Product Change Notice (PCN)

PCN Number: PCN-0370542-01

CMT-8504-100-SMT-TR

Description of Change:

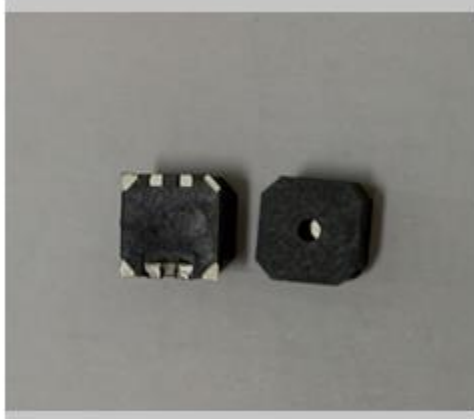
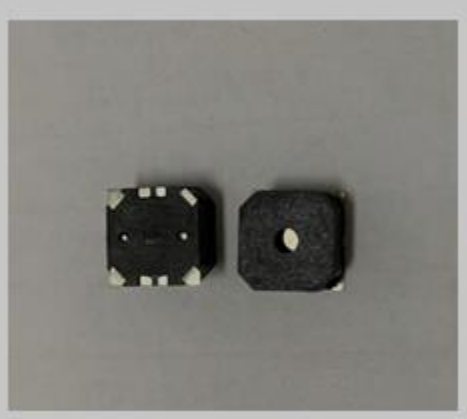
Improving the structure by changing the bottom to integrated with injection molding, and the connection parts being put inside. The item will now be done by machine to increase the capacity of production.

The only change is the injection Molding. This does not change any of the Characteristics of the product.
